**AMENDMENT #2**  
**November 8, 2022**  
**Invitation for Bids (IFB) Number**  
**GC-21-WCW1Upgrade-01, 10/19/2021**  
**Issued by**  
**Gillespie County Water Control and**  
**Improvement District No. 1**  
**Fredericksburg, Texas**

**PURPOSE OF AMENDMENT**

1. To transmit a Revised Bid Schedule, some revised drawings and specifications, pen-and-ink changes to Parts 1-3, and to provide meeting minutes (including Questions and Answers) and attendance list for the 11/1/2022 Pre-bid Conference/Site Showing.
2. To remind bidders that oral explanations or instructions given before the award of the contract will not be binding. See PART I, Subpart B, Instructions to Bidders, Section 6.

**GEOLOGICAL INVESTIGATIONS PROFILES**  
 FLOODWATER RETARDING STRUCTURE SITE No. 1 UPGRADE OF THE  
 WILLIAMS CREEK WATERSHED  
 IN  
 BLANCO, GILLESPIE, & KENDALL COUNTIES, TEXAS

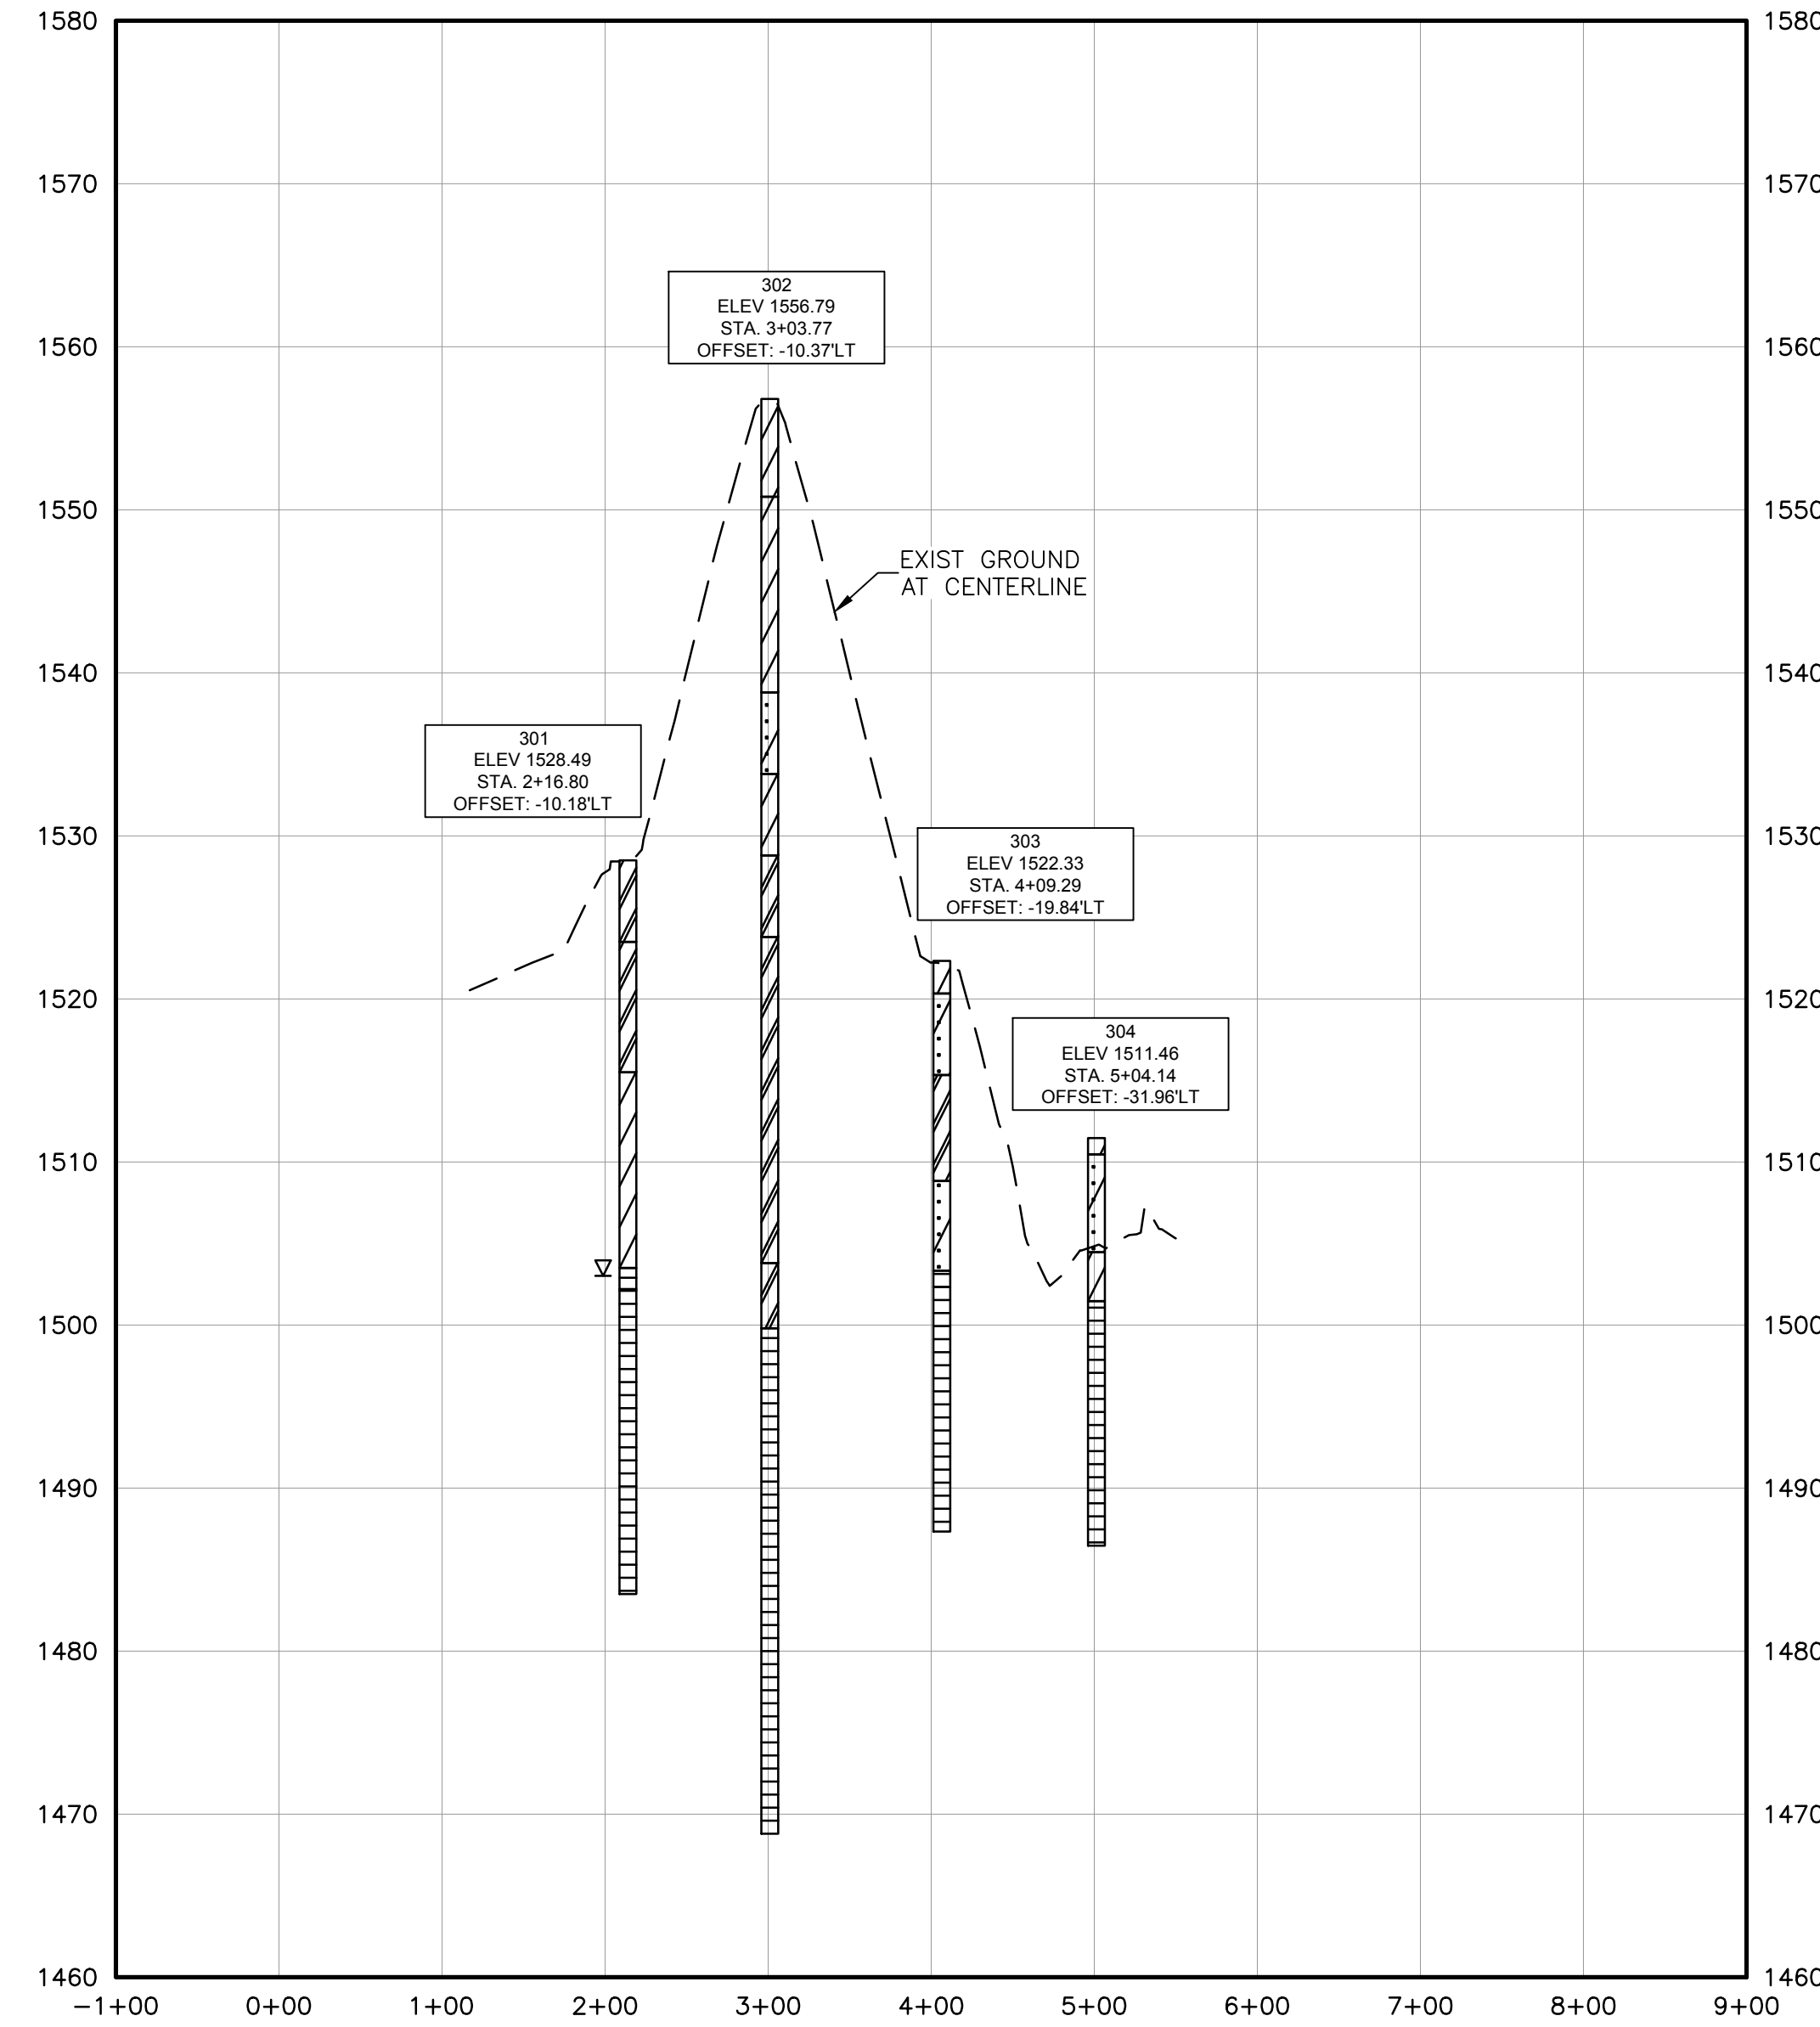
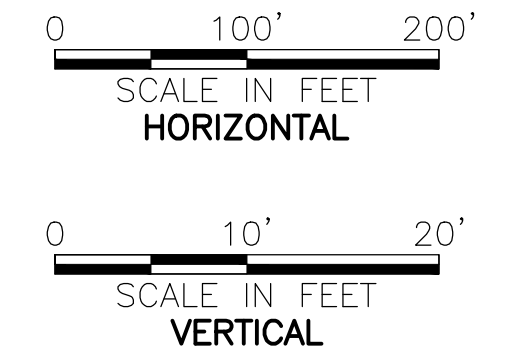
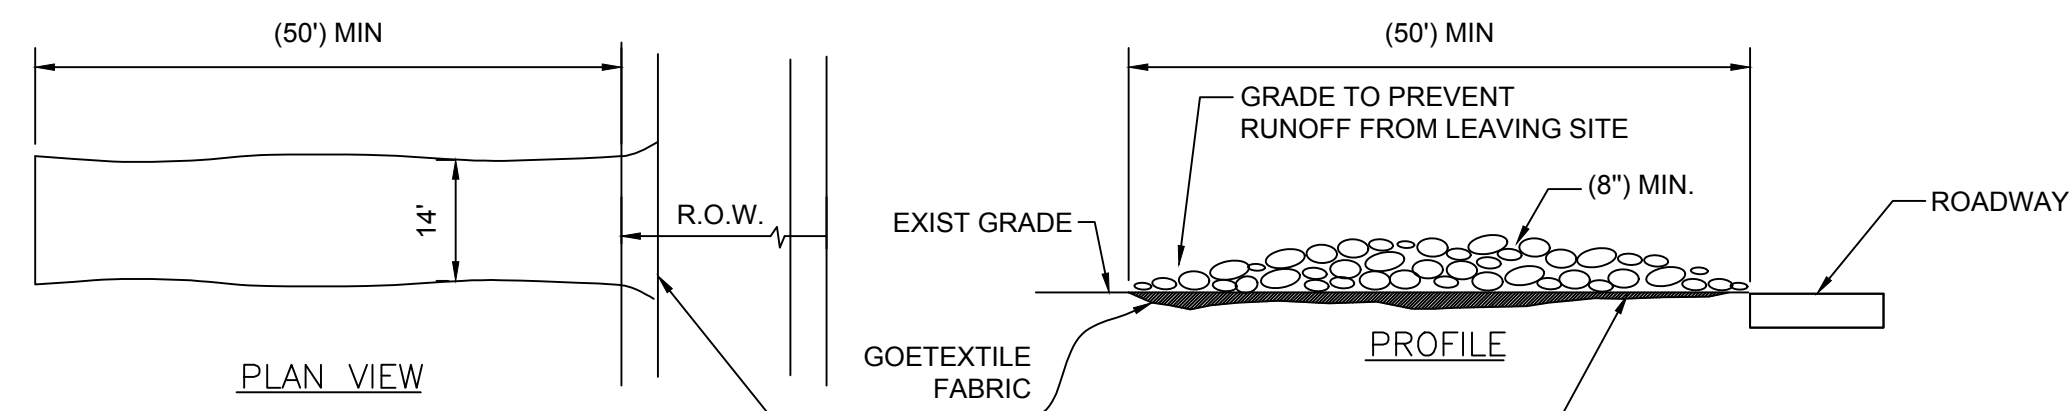
REVISIONS			
ADDENDUM	DATE	APPROVED	TITLE
A	2022.11.08	NC	ADDENDUM NO.2
